Design Update

Non Material Amendment Supporting Document

A283-MCO-XX-XX-DS-A-04001

THE REPUBLIC

Proposed NMA L07 Drawing

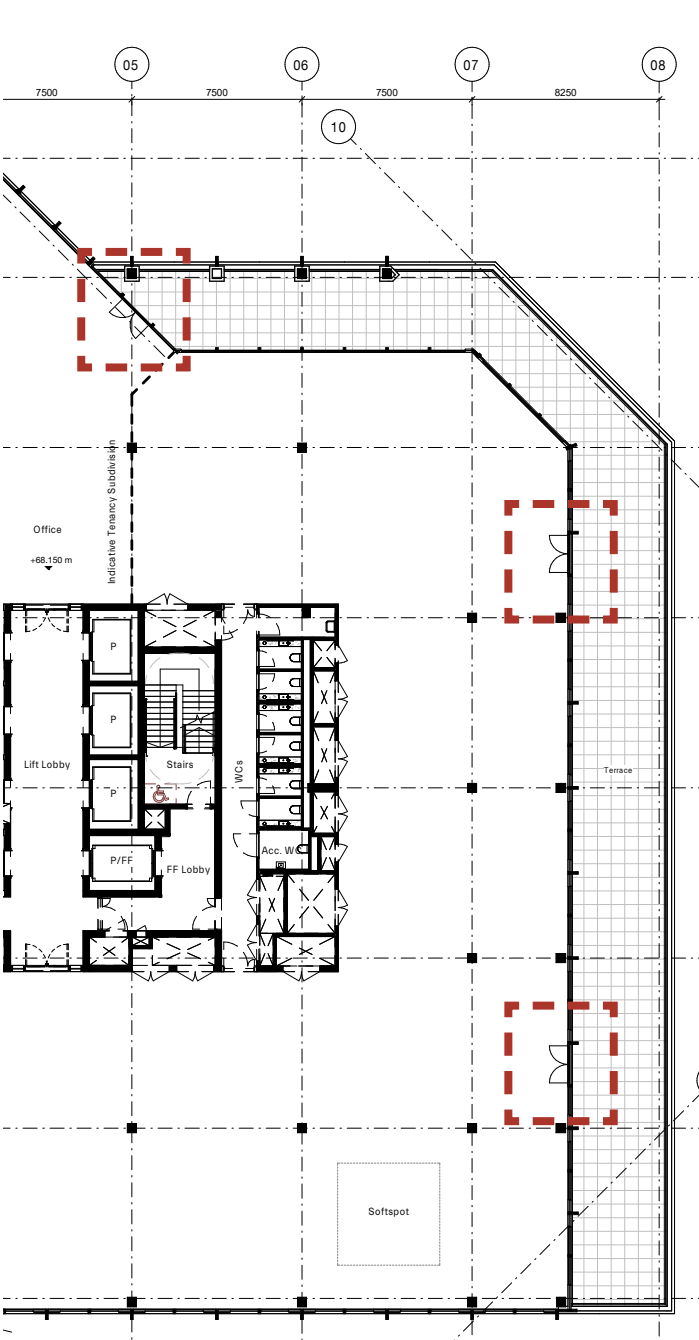
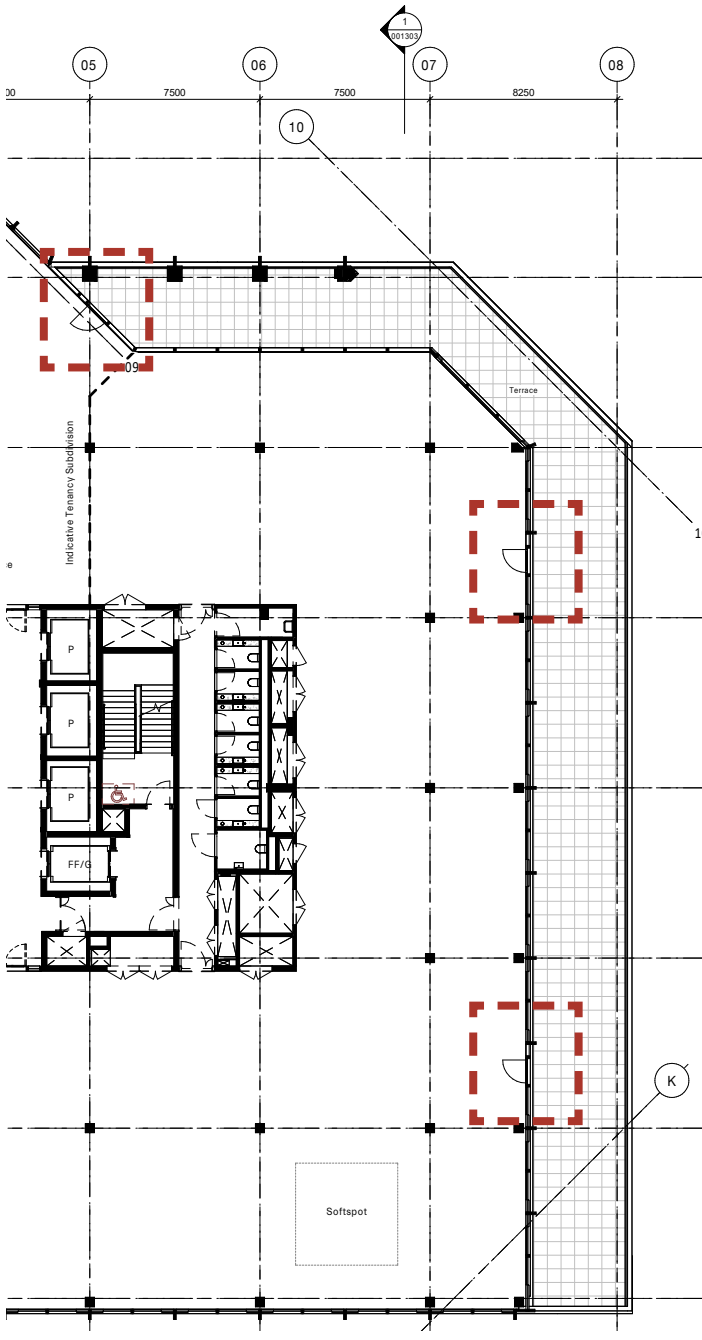
+ External doors adjusted to best reflect the facade rhythm and meet performance requirements, as shown below.
